Determination 2025/002

An authority's proposed refusal to grant a building consent for two multi-unit buildings in relation to the application of C/AS1 Part 5

172 Blenheim Road, Riccarton, Christchurch

Figure 2: Site plan, including distances to the relevant boundaries (not to scale)

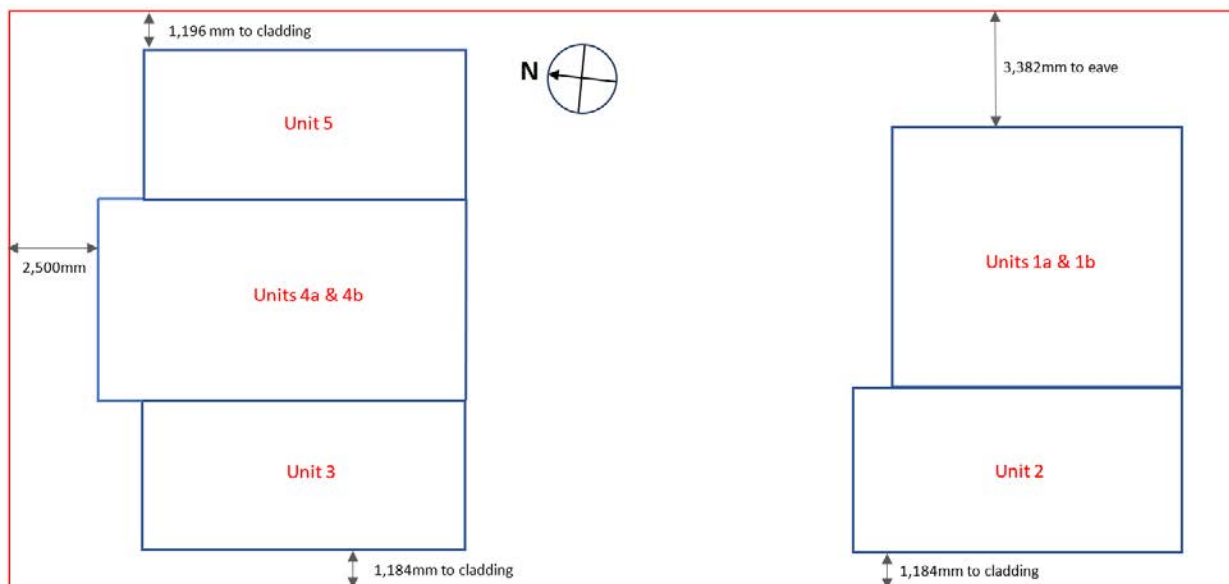
- 2.4. Regarding the buildings' external walls, units 1a, 1b, 4a and 4b are within 5.0m of relevant boundaries³ to the neighbouring properties beyond the development site, while units 2, 3, 5 are further than 1.0m from these relevant boundaries. Plans submitted with the consent application show two-way fire separation between the units is proposed to create separate fire cells.

[The authority] interprets that clause 5.1.1 of C/AS1 applies to the whole building and not just individual household firecells. Please revisit the design to provide the necessary 30 minutes fire resistance rating where the external walls of these buildings (x2) are less [than] 5.0m from the relevant boundary.

Both proposed buildings appear to contain units stacked one above the other. As such, C/AS1 5.1.1(b) shall be applied to the buildings. Since the buildings are shown to be less than 5.0 meters [sic] from the relevant boundaries and not all external walls within 5.0 meters of the boundaries are fire-rated, the proposal does not comply with C/AS1 5.1.1(b). Please revise the design to show compliance with C/AS1 5.1.1(b) or justify compliance with the [Building Code] following an appropriate methodology.

- 4.3. The authority has not provided a submission, but in correspondence with the owner in June 2024 stated that it does not accept that C/AS1 paragraph 5.1.1(a) and paragraph 5.1.1(b) can be applied to different parts of the same building as "C/AS1 5.1.1 does not include wording referring to how different uses or parts of the building could have different requirements".

5.16. I consider the provisions described in 5.1.1(a) and (b) require an *external wall* to be fire rated depending on the location of the relevant *household unit*, be it next to or above another, and this in turn contributes to compliance of the overall building. It is likely that a configuration of both side by side and one above another will occur in the same building, so one elevation could be made up of multiple *external walls* depending on the configuration of units. Different elevations can then be assessed.

- 5.18. Based on the above, I consider the provisions under both 5.1.1(a) and (b) can apply to one *building*, with an assessment made on each *household unit* within a *multi-unit dwelling*.
- 5.19. Units 2, 3 and 5 are proposed two-storey units which are side by side with other units. The proposed plans show these as being more than 1.0m from the relevant boundary. I consider this meets the requirements of C/AS1 paragraph 5.1.1(a).
- 5.20. Units 1a and 1b, and 4a and 4b are proposed single storey, single household units one above another. The plans show these as being within 5.0m of the relevant boundary to the neighbouring property and proposed to have FRR external walls. I consider this meets the requirement of C/AS1 paragraph 5.1.1(b).

- 6.1. In accordance with section 188 of the Building Act 2004, I reverse the authority's proposed decision to refuse building consent BCN/2022/7604 based on the interpretation of paragraph 5.1.1 of Acceptable Solution C/AS1.
